# VALUE ENGINEERING REPORT

**5 Lane Widening of SR 40**  
**West of Grove Boulevard to East of Truss Plant Road**  
NHS00-0002-00(861)  
Camden County  
PI No. 0002861  
June 24, 2009

**SR 40 Widening, West of Grove Blvd to East of Truss Plant Rd.**

IDEA No: A-2

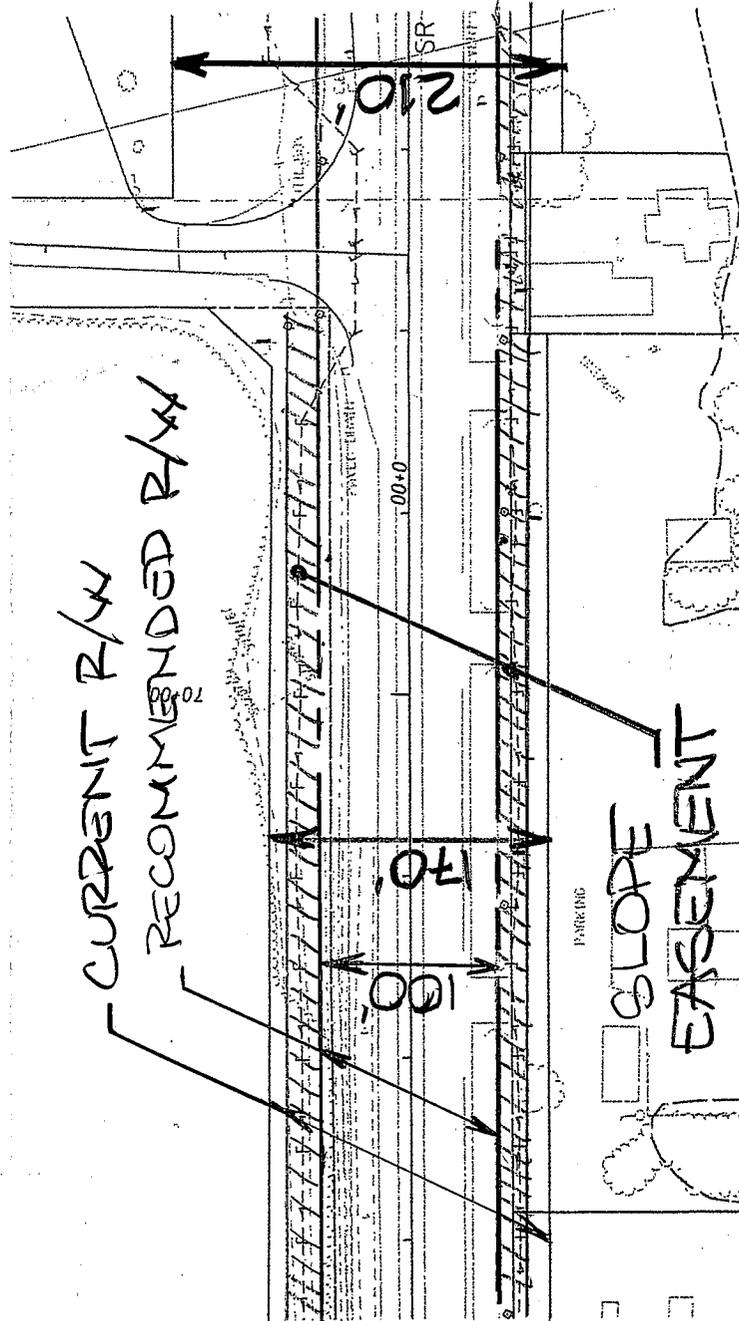
The proposed R/W width varies depending on the extent of the grading limit. The plans show R/W widths from 140 to 170 feet and up to 210 ft at the eastern section of the project.

Provide a consistent width R/W and acquire the remaining needed areas as slope easements. This recommendation assumes a 12 foot shoulder however it will also be valid with 16 ft shoulders.

The existing R/W width is 100 feet which is adequate for a 5 lane section with 12 foot urban shoulders This includes the total width of the required typical section between shoulder break points. The remaining areas required can be secured as slope easements which are generally less expensive than full R/W acquisition.

IDEA No: B-1.1

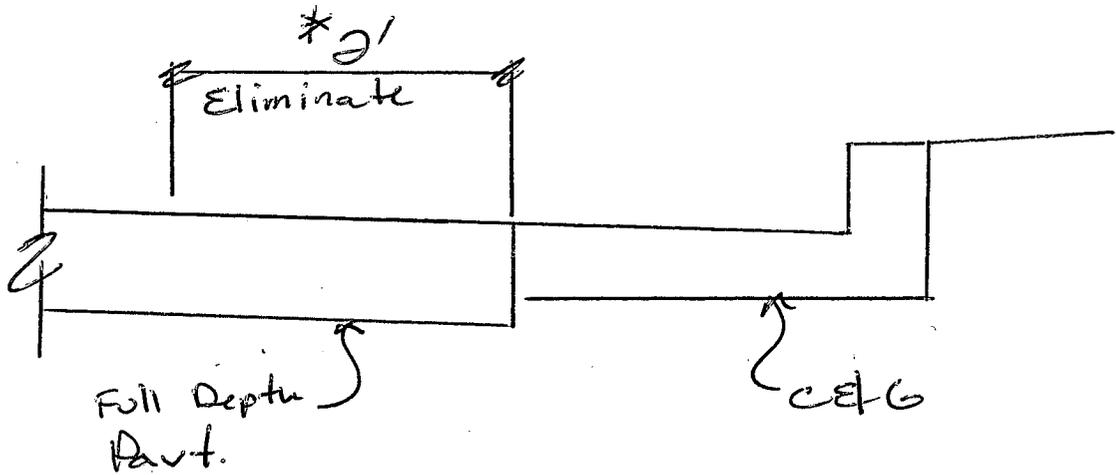
Use 12' thru lanes in each direction.

Use 11' thru lanes in each direction.

11' lanes will function as well as the 12' lanes and are in compliance with AASHTO guidelines. Due to the proposed curb and gutter, there will be an additional 2 ft offset to the face of the curb which will provide suitable space for trucks and busses. This recommendation will reduce material costs and R/W acquisition. In addition to the calculated cost savings, there are other miscellaneous savings including earthwork, lateral pipes and tack coat. Overall, the impervious areas are also reduced.

\* Save 2' full-depth widening  
in Each Direction for a  
total of 4'

IDEA No: B-1.2

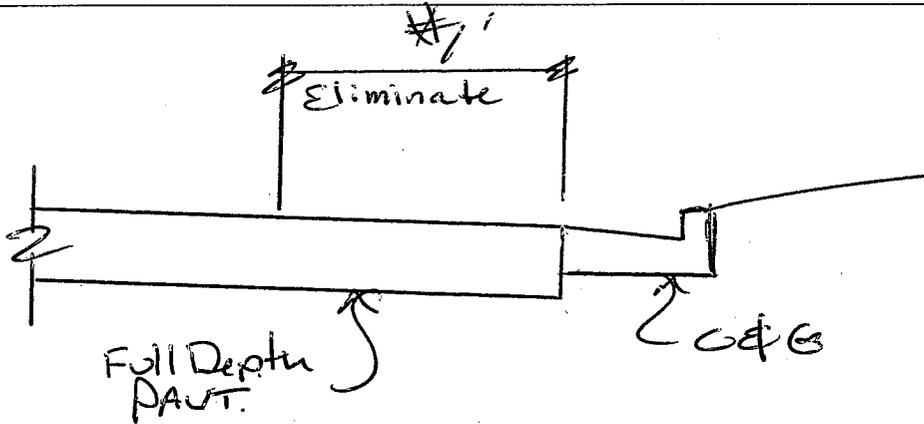
Use 2-12' thru lanes in each direction.

Use 11' inside lanes and 12' outside lanes.

This recommendation would function similar to 2-12' lanes in each direction and is in compliance with AASHTO guidelines. The 12' outside lanes would accommodate the 7% truck traffic. There will be a reduction in material costs and R/W acquisition. In addition to the calculated cost savings, there are other miscellaneous cost savings such as earthwork, lateral pipe lengths, tack coat, etc.

\* Save 12" full depth part  
in Each Direction for  
a total of 2'

IDEA No:  
B-4.1

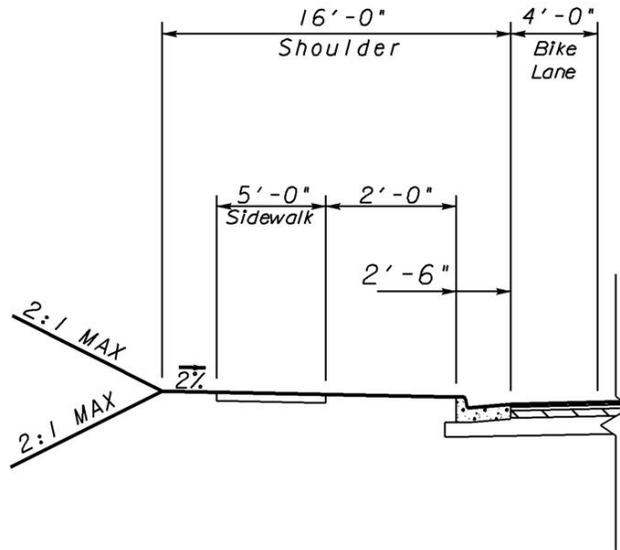
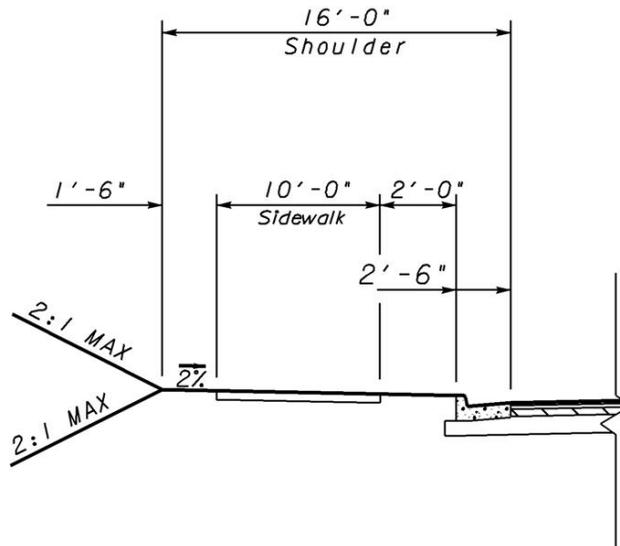
<b>DEVELOPMENT AND RECOMMENDATION PHASE</b>			
<b>SR 40 Widening, West of Grove Blvd. to East of Truss Plant Rd.</b>			
<b>IDEA No.:</b> B-4.1	<b>Sheet No.:</b> 1 of 4	<b>CREATIVE IDEA:</b> Move the bicycle lanes behind the curb and incorporate with sidewalks as a multi-use trail	
<b>Prepared By:</b> AW		<b>Date:</b> 06/10/09	<b>Checked By:</b> GAO <b>Date:</b> 6-15-09
<p><b>Original Concept:</b> The original concept calls for 4' bike lanes on each side of SR 40.</p> <p><b>Proposed Change:</b> The current shoulder section is 16' wide and calls for a 5' sidewalk. This leaves 8.5' of grassed area that could be used for a 10' sidewalk and leave 2' between the back of curb and sidewalk and 1.5' between the sidewalk and shoulder break line. These wide sidewalks can be used as multi-use trails which would eliminate the need for the bike lanes on SR 40.</p> <p><b>Justification:</b> By shifting the bike lanes out of the roadway, this will create a safer place for the cyclist and eliminate the need for some full depth asphalt. Safe and protected crossings are provided at the signalized intersections at Grove Blvd and Truss Plant Road.</p> <p>Right of way savings due to the reduced typical section are not included in the cost savings since the potential 12 ft shoulder would have to be widened to 16 ft. If the 12 ft shoulder is not considered, additional R/W savings could be achieved.</p>

IDEA No: B-4.2

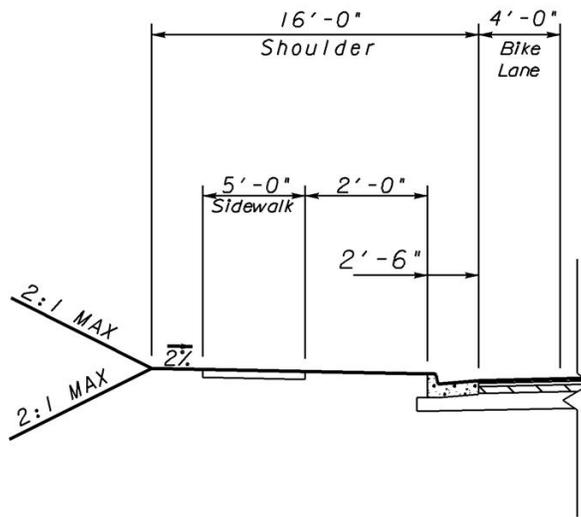
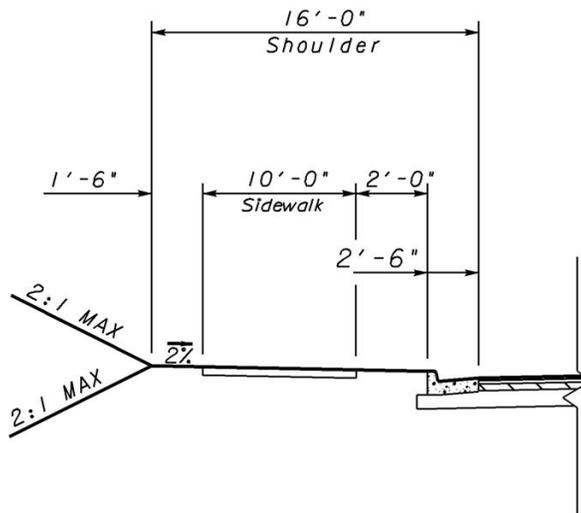
<b>DEVELOPMENT AND RECOMMENDATION PHASE</b>			
<b>SR 40 Widening, West of Grove Blvd. to East of Truss Plant Rd.</b>			
<b>IDEA No.:</b> B-4.2	<b>Sheet No.:</b> 1 of 4	<b>CREATIVE IDEA:</b> Eliminate bicycle lanes and widen one sidewalk to 10' on one side of the street for use as a multi-use trail	
<b>Prepared By:</b> AW		<b>Date:</b> 06/10/09	<b>Checked By:</b> GAO <b>Date:</b> 6-15-09
<p><b>Original Concept:</b> The original concept calls for 4' bike lanes on each side of SR 40.</p>			
<p><b>Proposed Change:</b> The current shoulder section is 16' wide and calls for a 5' sidewalk. This leaves 8.5' of grassed area that could be used for a 10' sidewalk and leave 2' between the back of curb and sidewalk and 1.5' between the sidewalk and shoulder break line. If one of the sidewalks on one side of the street is widened to 10' it can be used as a multi-use trail which would eliminate the need for the bike lanes on SR 40.</p>

<p><b>Justification:</b> By shifting the bike lanes out of the roadway, this will create a safer place for the cyclist and eliminate the need for some full depth asphalt. Safe and protected crossings are provided at the signalized intersections at Grove Blvd and Truss Plant Road.</p> <p>Right of way savings due to the reduced typical section are not included in the cost savings since the potential 12 ft shoulder would have to be widened to 16 ft. If the 12 ft shoulder is not considered, additional R/W savings could be achieved.</p>			
LIFE CYCLE COST SUMMARY	CAPITAL COST	FUTURE COST	TOTAL COST
<b>INITIAL COST - Original</b>	370,000		
<b>- Proposed</b>	115,000		
<b>- Savings</b>	255,000		255,000
<b>FUTURE COST – Savings</b>			0
<b>TOTAL PRESENT WORTH SAVINGS</b>			<b>255,000</b>

IDEA No:  
B-7

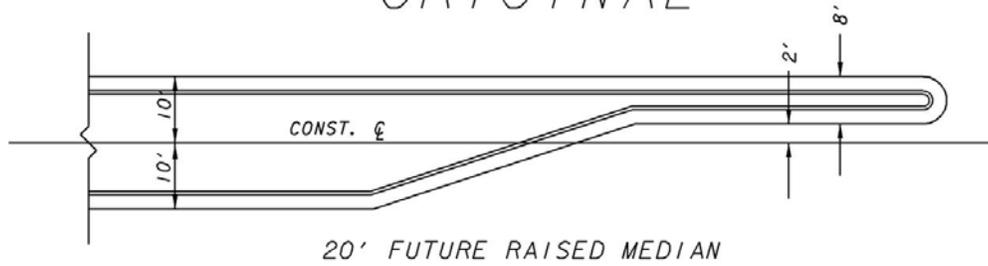
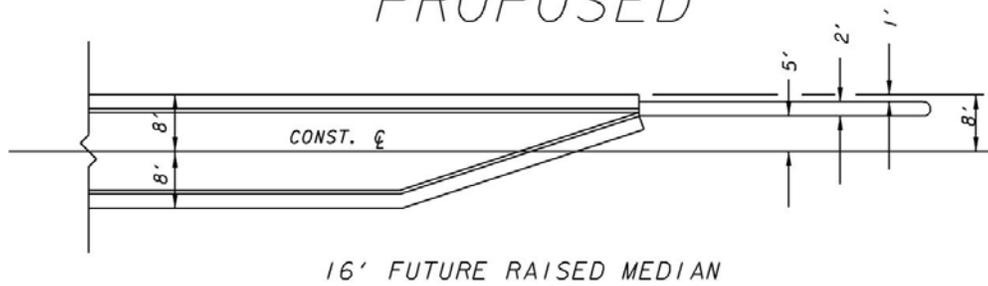
<b>DEVELOPMENT AND RECOMMENDATION PHASE</b>			
<b>SR 40 Widening, West of Grove Blvd to East of Truss Plant Rd.</b>			
<b>IDEA No.:</b> B-7	<b>Sheet No.:</b> 1 of 4	<b>CREATIVE IDEA:</b> Use 16 foot median in lieu of 20 ft	
<b>Prepared By:</b> GAO		<b>Date:</b> 6-11-09	<b>Checked By:</b> AW <b>Date:</b> 6-12-09
<p><b>Original Concept:</b> Provide space for future 20 ft raised median</p> <p><b>Proposed Change:</b> Use a 16 ft median</p> <p><b>Justification:</b> A 16 foot median provides the same function as a 20 foot median with provisions for a 12 foot turn lane and a 4 foot offset at the median openings. The narrower section will provide reduced pavement construction and R/W costs. Additional future savings will be realized when the decision is made to construct a 16 median in lieu of a 20 foot.</p>			
<b>LIFE CYCLE COST SUMMARY</b>	<b>CAPITAL COST</b>	<b>FUTURE COST</b>	<b>TOTAL COST</b>
<b>INITIAL COST - Original</b>	872,000

IDEA No: B-9

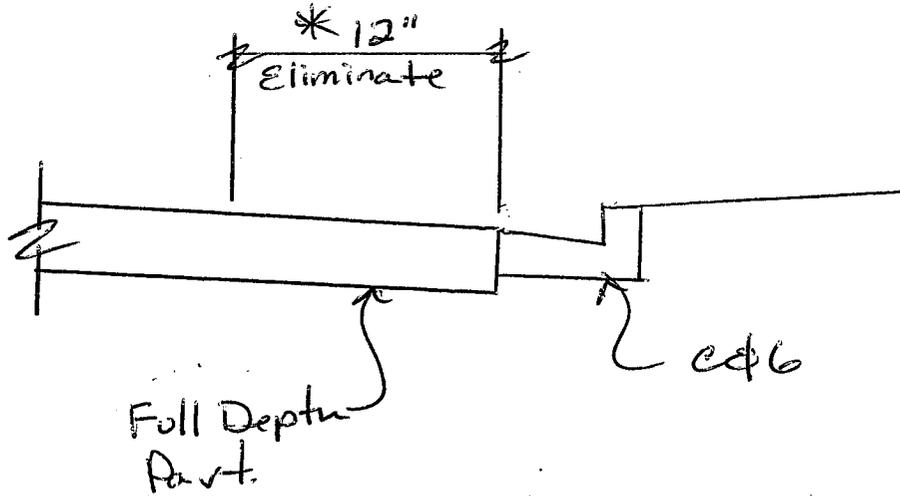
Provide a 14' wide center left turn lane.

Change the center left turn lane to 12' wide.

The 12' center left turn lane will function the same as the 14' lane. There will be a reduction in material costs and R/W taking. In addition to the calculated cost savings, there are other miscellaneous cost savings such as earthwork, lateral pipe lengths, tack coat, etc.

\* Save 12" Full-Depth Part.  
in Each Direction for a  
total of 2'

B-11.1

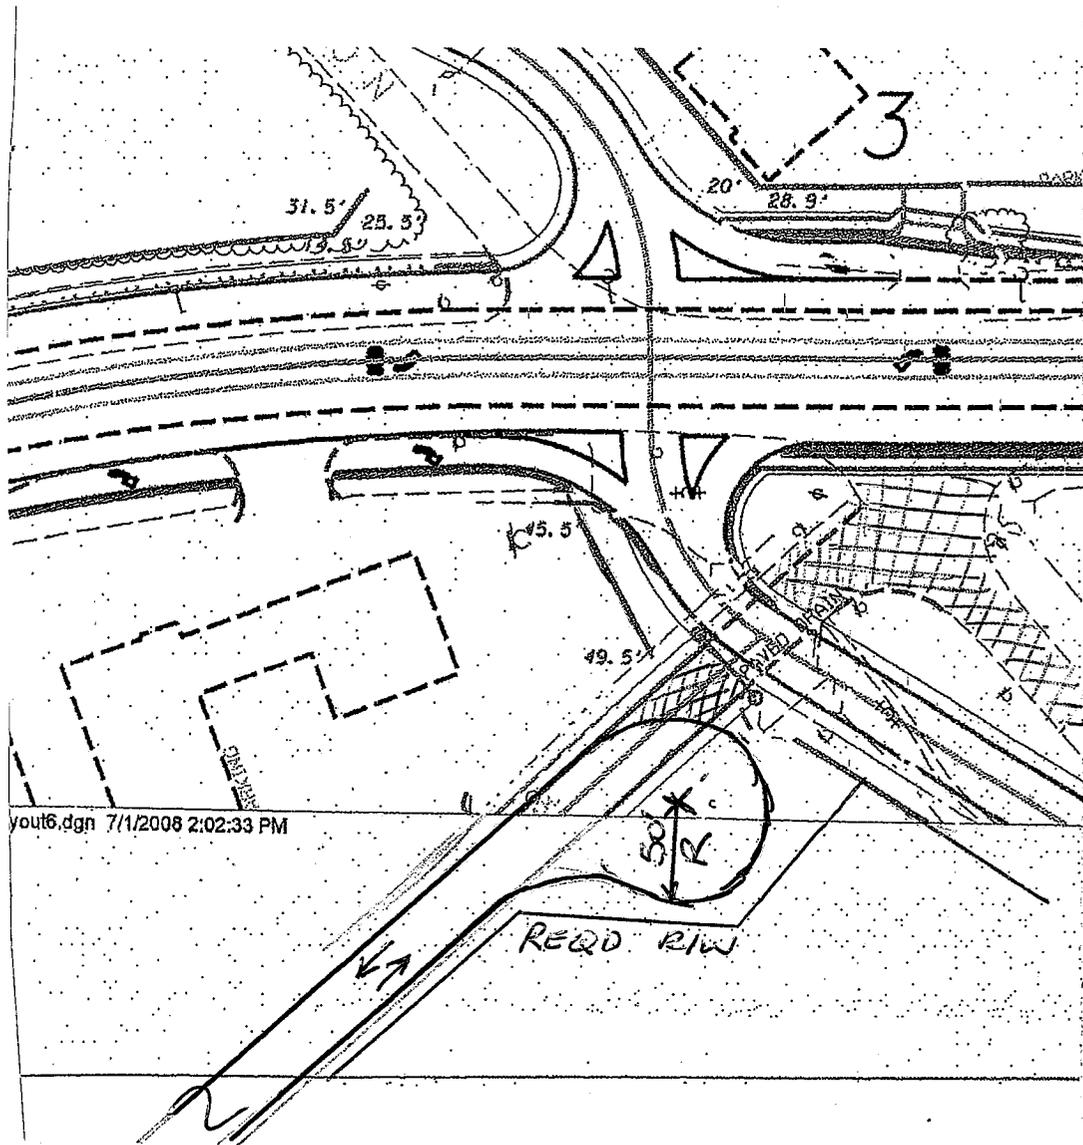
<b>DEVELOPMENT AND RECOMMENDATION PHASE</b>			
<b>SR 40 Widening, West of Grove Blvd to East of Truss Plant Rd.</b>			
<b>IDEA No.:</b> B-11.1	<b>Sheet No.:</b> 1 of 4	<b>CREATIVE IDEA:</b> Realign Grove Blvd to match concept report and close E. Williams with a Cul-De-Sac.	
<b>Prepared By:</b> SSB		<b>Date:</b> 6/10/2009	<b>Checked By:</b> GAO <b>Date:</b> 6-15-09
<p><b>Original Concept:</b> Provide a minimal shift on Grove Blvd and leave E. Williams open at the intersection at Groves.</p> <p><b>Proposed Change:</b> Realign Grove Blvd and provide a better intersection angle. Close E. Williams at the Intersection of Grove Blvd with a cul-de-sac.</p> <p><b>Justification:</b> This intersection is at a very poor skew angle and location on SR 40, on a horizontal curve. The project improvements for the SR 40 widening should address this intersection. The proposed realignment shown for Grove Blvd indicates a 70 degree skew angle, which is acceptable however, the intersection would not operate as such due to the very short tangent section between the 2 approaching curves. The effects of the realignment would not be achieved once the striping plans are developed. Most likely, opposing direction traffic will be in conflicting lanes and the operations and safety of this intersection will be affected. Even though there will be a cost increase, the realignment should match a layout found in an earlier concept report as shown on the sketch. This would provide much better operations and safety at the intersection.</p> <p>This recommendation also includes eliminating the access on E William Avenue which is further detailed and discussed in recommendation B11-2.</p>

IDEA No: B-11.2

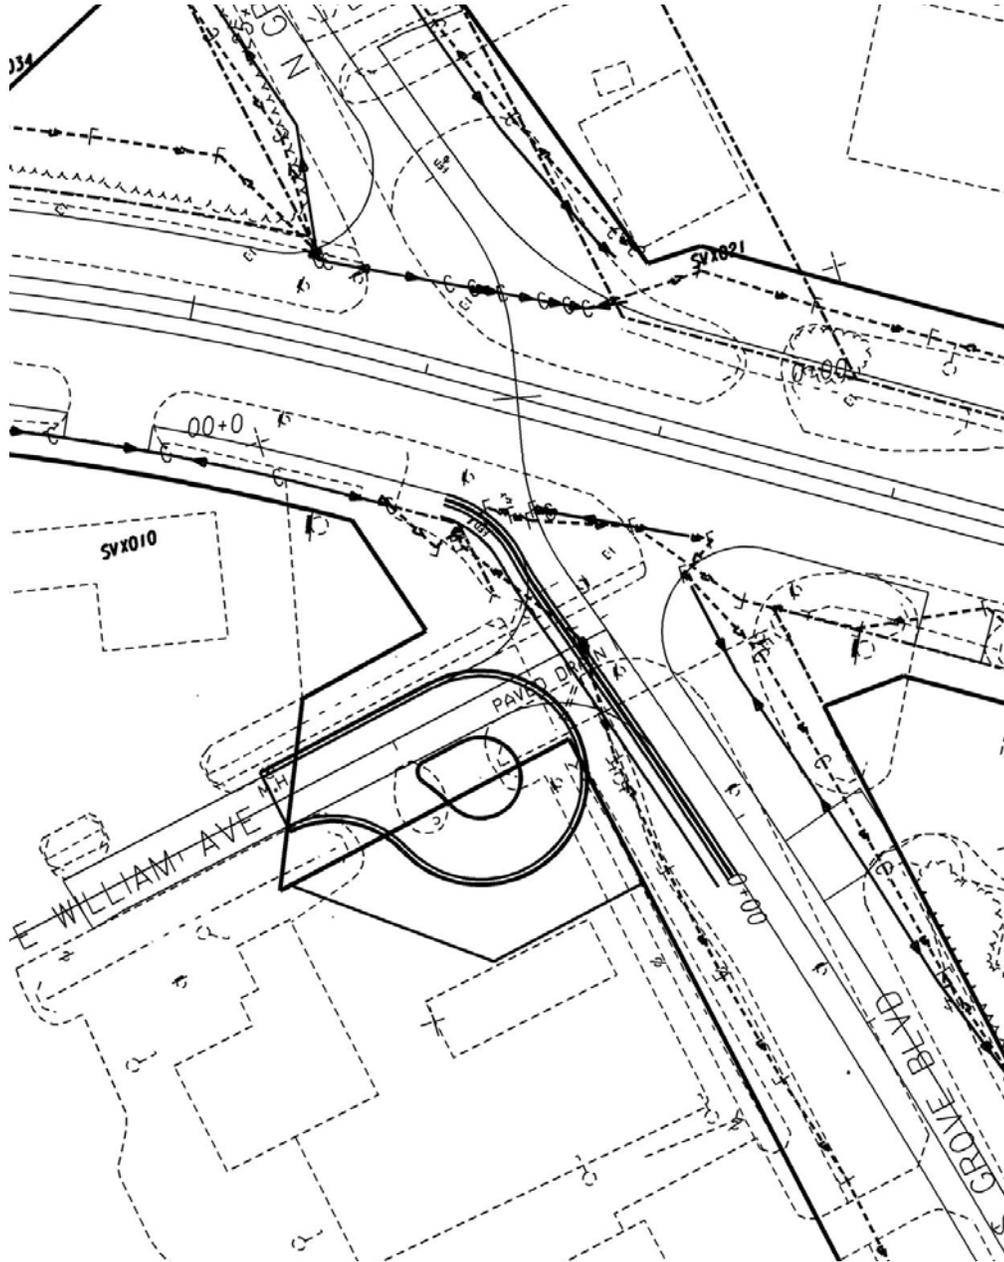
<b>DEVELOPMENT AND RECOMMENDATION PHASE</b>			
<b>SR 40 Widening, West of Grove Blvd to East of Truss Plant Rd.</b>			
<b>IDEA No.:</b> B-11.2	<b>Sheet No.:</b> 1 of 4	<b>CREATIVE IDEA:</b> Close E. William Avenue with a cul-de-sac.	
<b>Prepared By:</b> SSB		<b>Date:</b> 6/10/2009	<b>Checked By:</b> GAO <b>Date:</b> 6-15-09
<p><b>Original Concept:</b> Tie E William Ave. at Grove Blvd and convert to a right in / right out condition.</p> <p><b>Proposed Change:</b> Close E. William Ave. at the intersection of Grove Blvd and eliminate the right in / right out with a cul-de-sac.</p> <p><b>Justification:</b> This is a poorly aligned and problematic intersection as discussed under recommendation B11.1. It is further exacerbated by the E William Ave. intersection. Even though the current design is to convert it to a right in / right out condition, its proximity to SR 40 would still continue to be an unsafe condition. Traffic accessing E William Ave. could potentially back onto SR 40. From the aerial photography and after review of the video inventory for the area, this appears to be a low volume road with convenient access to SR 40 at East Street, about 1,500 feet west of Grove Blvd.</p> <p>Eliminating E. William Ave. access to Grove Blvd at the intersection would add project costs however it would provide much better operations and safety at the intersection. The affected property would not require a total taking and therefore should not require an EA document. This recommendation can be implemented independently from the Grove Blvd alignment.</p>

IDEA No: B-13

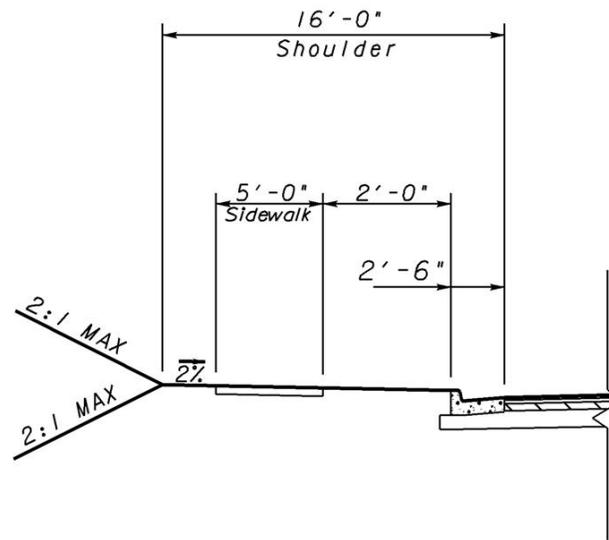
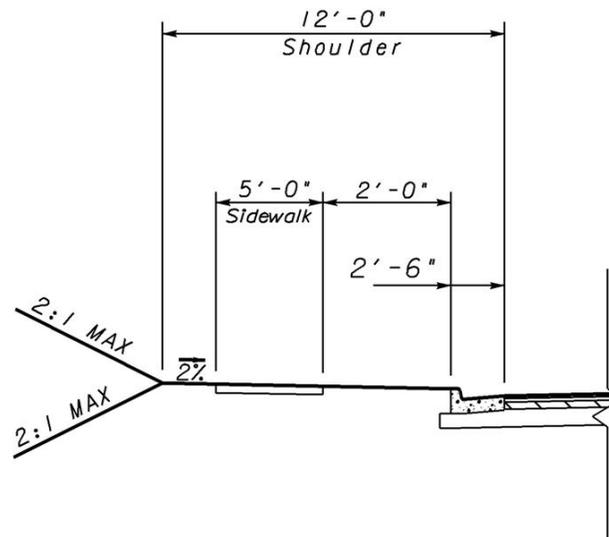
The original concept calls for 16' wide urban shoulders from normal edge of pavement to shoulder break.

Use 12' wide urban shoulders in lieu of 16' wide. This will accommodate the 2 ½' wide curb and gutter, the 5' sidewalk, the 2' grassed buffer between the curb and the sidewalk, and the 2 ½' shoulder from the back of the sidewalk to shoulder break.

The right of way costs are nearly 60% of the total project budget. Narrowing the shoulder width will reduce this cost while providing a similar function. 12 foot shoulders will provide ample room for the utility zone and full width sidewalks.

IDEA No: **B-16**

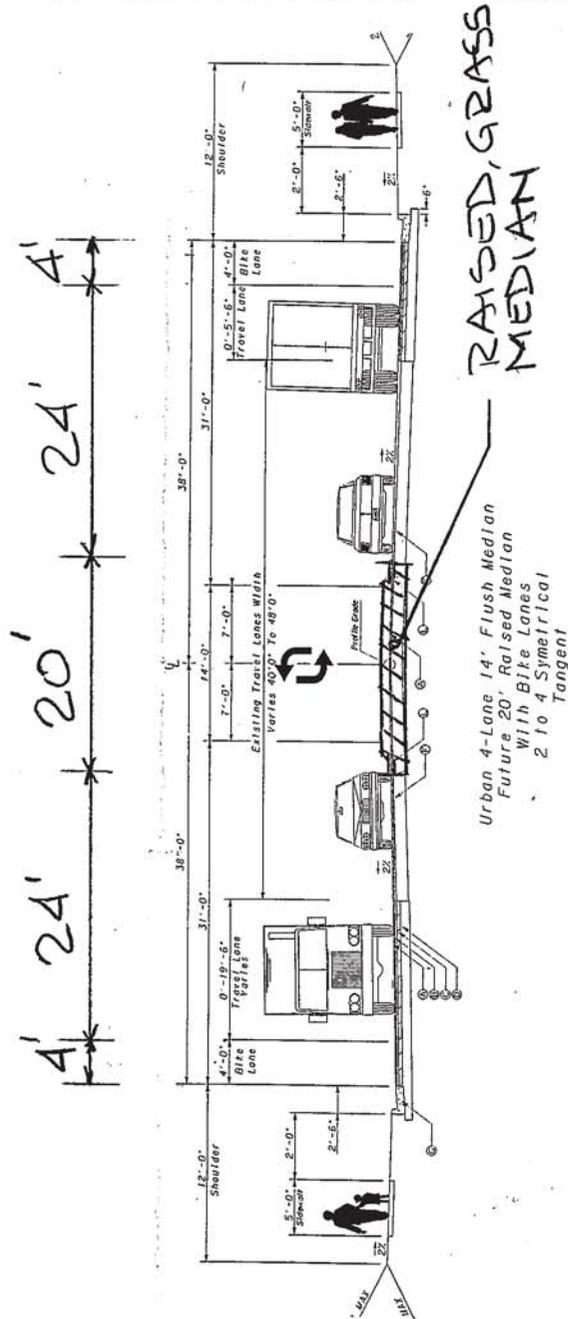
Construct the 5 lane, flush median with provisions for a 20 foot raised median in the future, when traffic conditions warrant.

Construct the 20 ft raised median as part of this project.

The project is being developed to incorporate a future 20 foot raised median with the expectation that future traffic conditions and continued corridor development will warrant it. Constructing the raised median as part of this project should be considered. Even though it will be slightly more costly in the short term, it will be much less problematic and more cost efficient in the long term. Incorporating a raised median with a center turn lane in place can be problematic and is usually met with strong opposition from the local business owners. The additional costs, traffic disruption and local community involvement, approvals and coordination can be eliminated if it is constructed as part of this project, especially if this is expected to occur in the reasonably near future, say 5 years.
